SUBJECT: Comments on “DRAFT REPORT - Dam Safety Assessment of CCW Impoundments: TVA Allen Fossil Plant”

Re: Response to Recommendations
USEPA CCR Impoundment Assessment DRAFT Report
Allen Fossil Plant (ALF)
Memphis, Tennessee

Re: USEPA CCR Impoundment Assessment DRAFT Report
Allen Fossil Plant (ALF)
Memphis, Tennessee

TENNESSEE VALLEY AUTHORITY (TVA) – COMMENTS ON COAL ASH SITE ASSESSMENT
ROUND 11 DRAFT REPORTS FOR ALLEN (ALF), BULL RUN, (BRF) COLBERT (COF),
CUMBERLAND (CUF), GALLATIN (GAF), JOHN SEVIER (JSF), JOHNSONVILLE, (JOF)
KINGSTON (KIF), PARADISE (PAF), SHAWNEE (SHF), WATTS BAR (WBF), AND WIDOWS
CREEK (WOF) FOSSIL PLANTS

Figure 2: Representative Cross Section for ALF East Ash Disposal Area

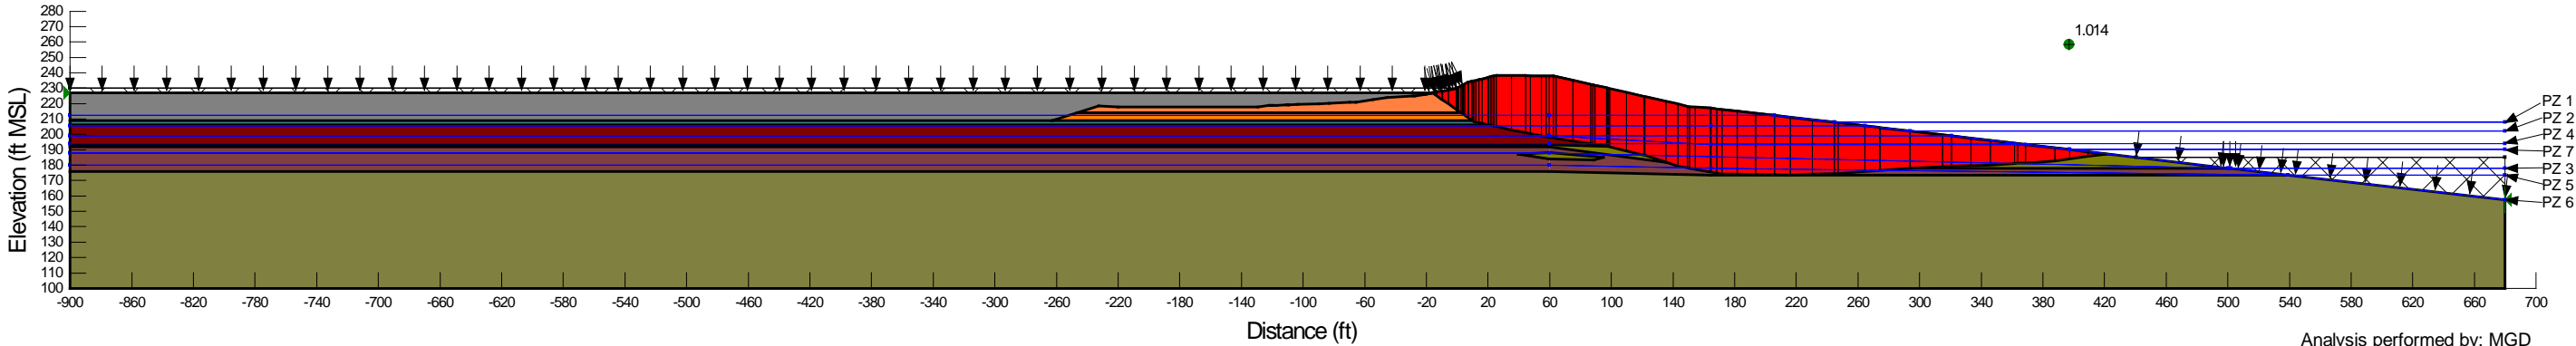
Figure 2 provides the cross section details developed from the existing information and the additional information obtained during the supplemental site investigation program. A significant result from the field investigation was the determination that pore pressures are significantly less than hydrostatic throughout the cross section. This means that effective stresses are higher and correspondingly soil strengths are higher than what is obtained if pore pressures are assumed to be hydrostatic below the top phreatic surface.

Figure 2 also includes a table that summarizes the soil strength parameters. A major effort was devoted to determining soil strength parameters with current state-of-practice methods. SPT testing was done under the observation of a geotechnical engineer or geologist to help ensure that all test conditions met the requirements of ASTM D1586. Cone penetration testing with shear wave velocity measurements was done to help define the layering and strength characteristics of the various soil layers. Field vane tests were run to measure in situ shear strength. Laboratory tests were run to determine undrained shear strength of cohesive strengths. Results of a laboratory test program on fly

Figure 3: Critical Failure Surface at Yield Acceleration for ALF East Ash Disposal Area

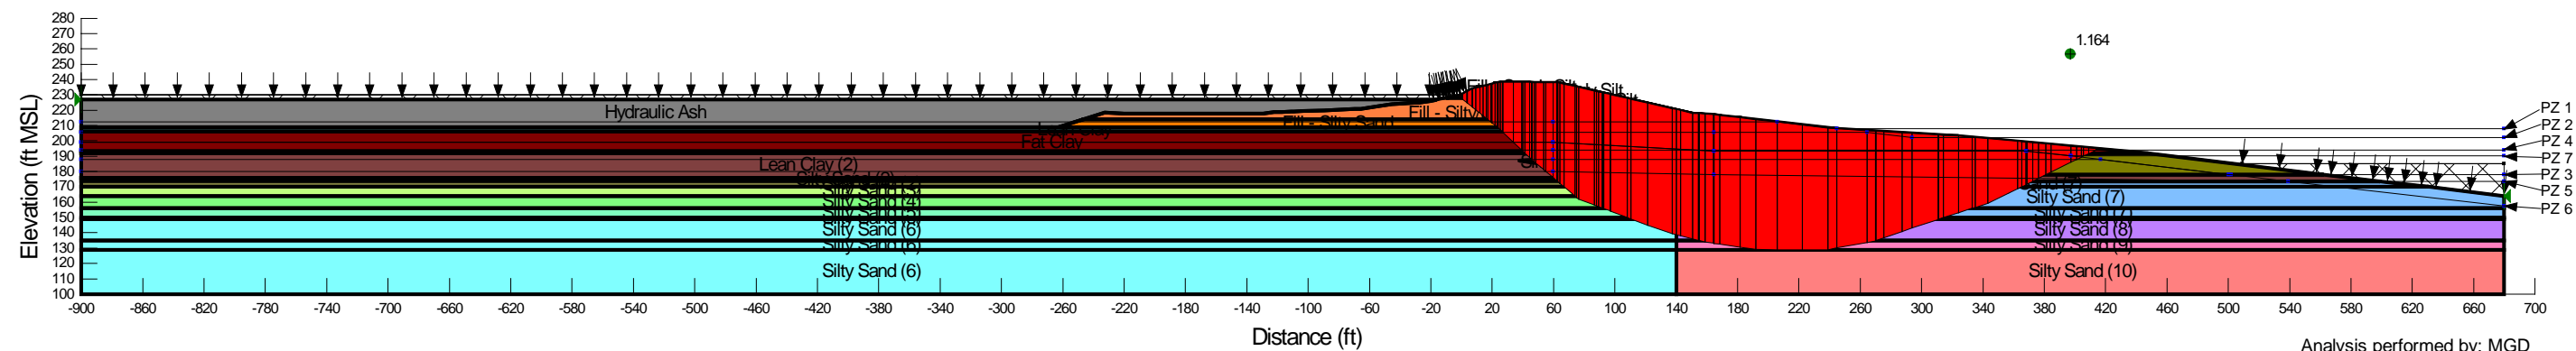
Section B-B' has a factor of safety against a global stability failure of 2.8 for current conditions. The yield acceleration for this section is 0.185g. The critical failure surface at this yield acceleration is shown in Figure 3.

Factor of Safety: 1.014
Horizontal Seismic Coefficient: 0.185

Figure 4: Critical Failure Surface for Post-Shaking Residual Shear Strength at ALF East Ash Disposal Area

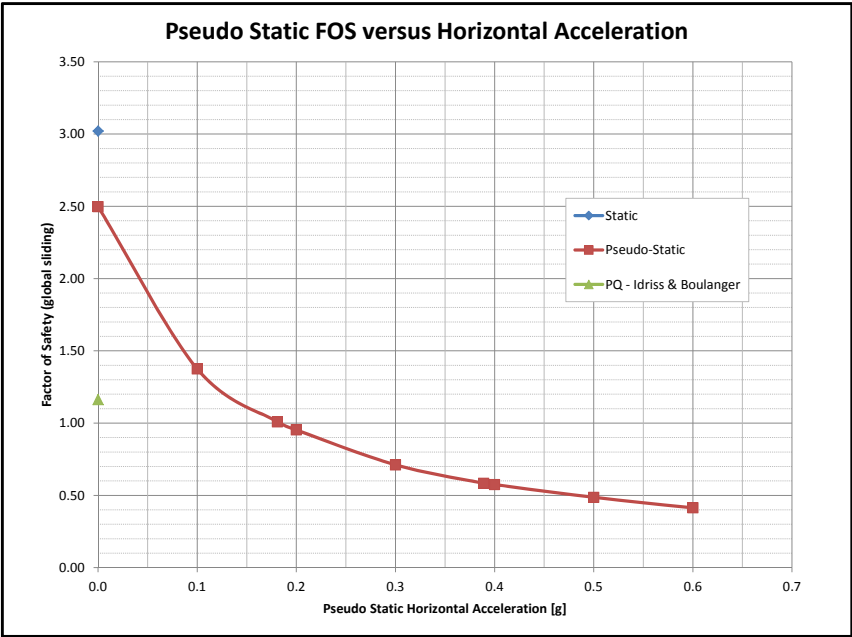
Since liquefaction may potentially occur for the design earthquake, the post-shaking stability of the slope comes into question. This was examined with stability analyses for static conditions but with reduced shear strengths. The pseudo-static strength values were used for all soils that do not liquefy. The residual shear strengths computed by the method of Idriss and Boulanger (2007) were used for the soils that may potentially liquefy. The computed residual strength values are given in Table 2 and 3 as well. Figure 4 shows the results of the post-shaking stability analysis. The factor of safety is 1.1 which is an acceptable value for this condition. The critical surface drops into the native silty sand layer that has relatively low blow counts.

Factor of Safety: 1.164
